### Secure 1000 Radiation Emission Measurement

**Re: Rapiscan AIT System Radiation Survey Reporting**

**R-0646-1 Addendum  
(Documentation Errors)**

Product Name	Secure 1000SP (Single Pose)
Serial Number	<b>S51039013</b>
Radiation Emission Measurement	Radiation Survey Dated: 12/07/2010
RSO Initials

**2. Radiation Leakage Measurement: Survey Table. 2**

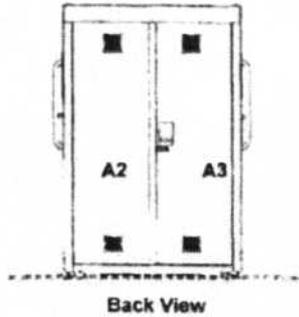
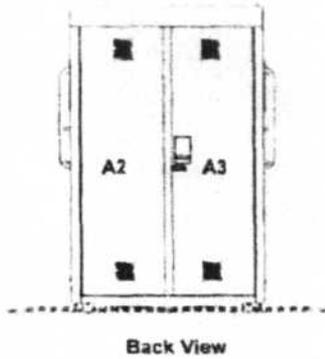
1. Technician did not note system parameters for kVP and mA. Correct values are 50kVP and 5mA.
2. TABLE 2: Incorrect presentation of data in Column 3 for Measured Exposure. Indicated value is .3 uRem. Technician did not zero out the survey meter between Inspection Zone Boundary readings. Accumulated dose was carried over resulting in a higher reading for zone A2. Corrected values are within applicable standards. The correct value should be 1 uRem.
3. TABLE 2: Incorrect presentation of data in Column 6 for Dose Equivalent. Indicated value is .54 uRem. Based on correction in Column 3 for Measured Exposure. The correct value should be 1.8 uRem.

The service technician should attend refresher training.

The corrected report indicates the system is within limits for applicable compliance and safety standards. No re-survey is required for this system.
